- 1. Fox Hills Estates Subdivision Part 3; KPB File 2023-146  
Edge Survey & Design, LLC / Swanson  
Location: Silver Fox Drive off Kalifornsky Beach Road  
Kasilof Area**

**ITEM #1 - PRELIMINARY PLAT  
FOXHILLS ESTATES SUBDIVISION PART 3**

<b>KPB File No.</b>	2023-146
<b>Plat Committee Meeting:</b>	January 22, 2024
<b>Applicant / Owner:</b>	Foxhills Estates Subdivision LLC of Kasilof Alaska
<b>Surveyor:</b>	Mark Aimonetti / Edge Survey & Design, LLC
<b>General Location:</b>	Kasilof/ Cohoe area

FOXHILLS ESTATES SUBDIVISION PART 3

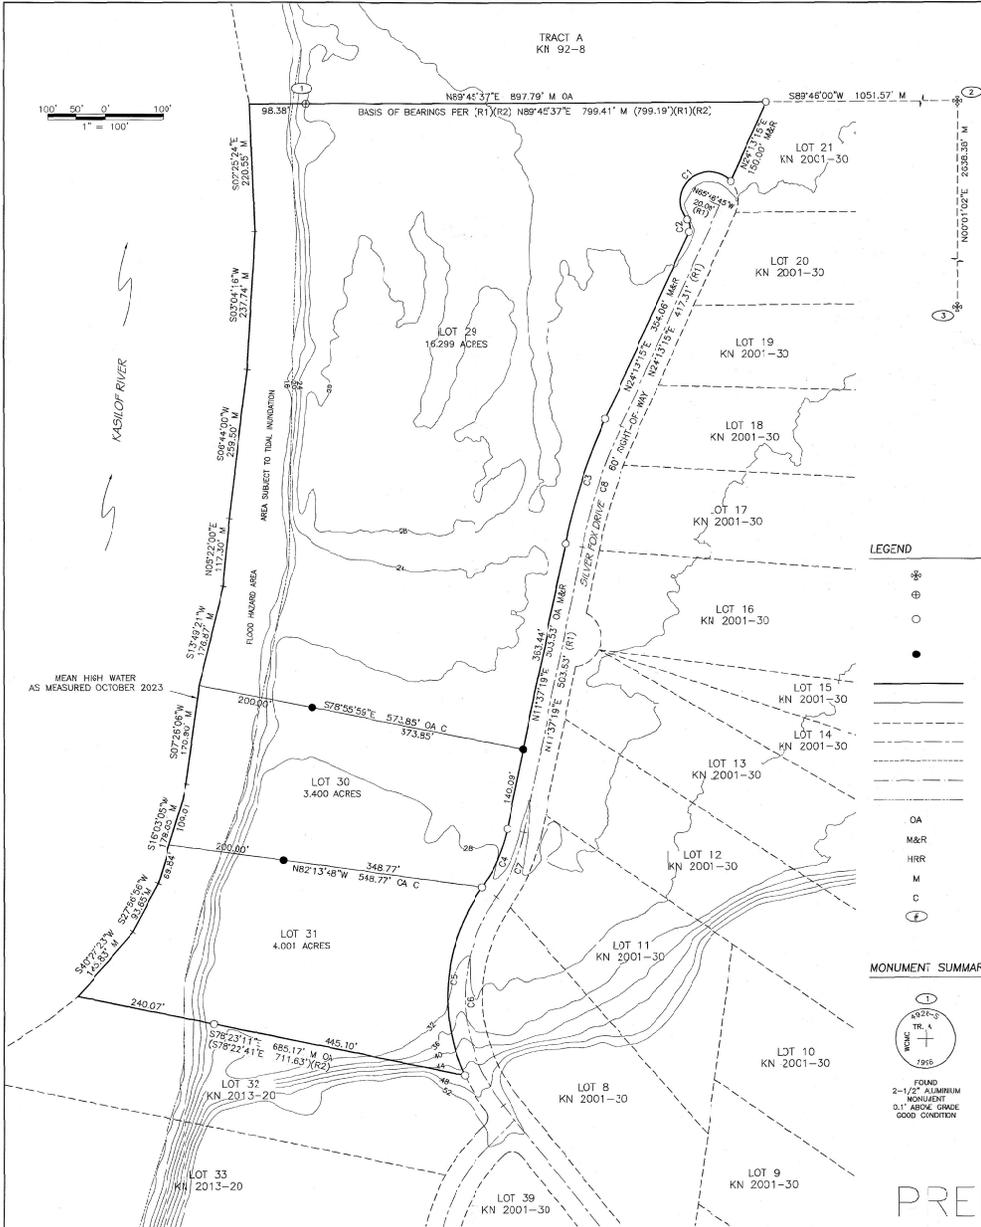
There are steep areas shown on the plat with the contours, but not identified as steep. These are near the edge of the separation for the drop to the flood hazard area as identified on the drawing. The steep areas are around 60 percent for a distance of about 30 feet, so not significant amounts of land. **Staff recommends:** surveyor label seep area and remove contours for final submittal.

A soils report will be required and an engineer will sign the final plat for lots 30 and 31. Lot 29 is over 200,000 sq ft and will not require a soil report. **Staff recommends:** the surveyor modify plat note 9 to the correct lot numbers and be aware that after the soils report is complete the wastewater disposal note may need changed.

Bring north arrow and scale together.  
 Monument 1 to monument 2 can be referenced to KN92-8 for distance, as it is within .05 feet.

Legal description should be revised to be similar to legal in certificate to plat with exceptions described.  
Add to KPB File No, 146 to make 2023-146.  
Total area of subdivision needs updated

Make name and right-of-way of Silver Fox Dr stand out better on the drawing.  
Add Red Fox Ln and R/W label to the drawing.

- The borough will not enforce private covenants, easements, or deed restrictions per KPB 20.60.170.
- Update the date in the Plat Approval to January 22, 2024.
